1. REPORT NUMBER 2. GOVT ACCESSION NO.	BEFORE COMPLETING FORM
	3. RECIPIENT'S CATALOG NUMBER
USAAEFA PROJECT NO. 78-10	Water W
4. TITLE (and Subtitle)	5. TYPE OF REPORT & PERIOD COVERED
AH-1G HELICOPTER 19-ROUND LIGHTWEIGHT AIRBORNE LAUNCHER	FINAL REPORT
JETTISON ENVELOPE DETERMINATION	MAY - PONE 1978

Director of Development and Engineering Position on the Final Report of USAAEFA Project No. 78-10, AH-1G Helicopter 19-Round Lightweight Airborne Launcher Jettison Envelope Determination, March 1979

Figure 1. LWL Test Loadings.

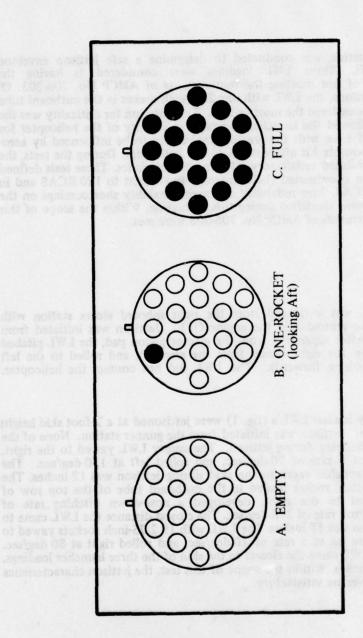
- 2. Paragraph 6 stated that the criterion for determining the critical launcher loading was that configuration that allowed the launcher to remain the closest to the helicopter for the longest period of time. Paragraph 10 states that an empty launcher had a jettison velocity of 23 ft/sec and that the critically loaded launcher, one rocket in launcher, had a jettison velocity of 19 ft/sec as stated in paragraph 11. The launcher with the lowest jettison velocity will be the launcher that remains the closest to the helicopter. In view of the above, the fully loaded launcher will weigh the most and consequently will have the lowest jettison velocity. This means the fully loaded LWL will be the most critical by the AEFA definition. (NOTE: This was not flown in forward flight.) The launcher that has the greatest tendency to fly is the empty launcher because it is the lightest. If the one rocket was placed in the bottom row at the inboard most location, the result would be a right roll which would result in less clearance. It appears that the most critical LWL was not tested. The critical launcher would result in a roll mode into the helicopter.

- 4. Further testing is planned for summer 1979 to complete the jettison envelope for full operational use. The issue of paragraph 2 above will be addressed during that test.

Photo A. Sway Brace Pads.

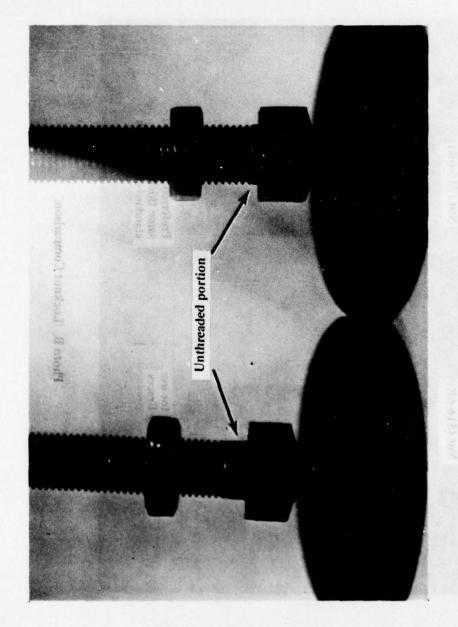
- 14. The sway braces of the ejector stores racks consist of four pylon fittings and four sway brace pads. The sway brace pad includes a 4-inch threaded adjustment bolt, a locknut (AN 316-6R), and a 2-inch diameter pad. Prior to attaching the LWL, the locknut is threaded on the adjustment bolt as far as possible toward the pad and then the adjustment bolt is threaded all the way into the pylon fitting. The sway brace pads available for this test were not identical, in that the adjustment bolts were threaded to different lengths (photo A). Those that were not threaded to the end could not be used, as the LWL could not be attached to the ejector stores rack due to insufficient clearance. Insufficient clearance existed between the launcher and the aft sway brace pads for the inboard stores pylon and between the launcher and the ejector piston pad for the outboard stores pylon. The incomplete threading of the adjustment bolts of the sway brace pads is a shortcoming.

- 15. The edges of the standard locknut (AN 316-6R) used on the sway brace pads rounded with normal use. This occurred because of the thinness of the locknut (photo B) and the lack of sufficient clearance between the pylon fitting and the sway brace pad adjustment bolt head for a standard size wrench, when the locknut was threaded as far up as possible on the adjustment bolt. Maintenance personnel had to periodically replace them to ensure proper security and adjustment of the LWL. This replacement increased the time required to mount the LWL. It should be noted that increasing the thickness of the locknut will further decrease the clearance necessary for mounting the LWL as mentioned in paragraph 14. The tendency for the sway brace pad locknut (AN 316-64) to round during normal use is a shortcoming.

- a. On production launchers, the lug attachment distance from the outer skin of the LWL to the bottom of the lug is increased from 1.00/1.08 to 1.15/1.25 inches. This increased distance will now allow the LWL to be installed on the outboard stores station. This modification also alleviates the shortcomings associated with the locknut and adjustment bolts of the sway brace pads with the increased clearance provided in the production LWL.
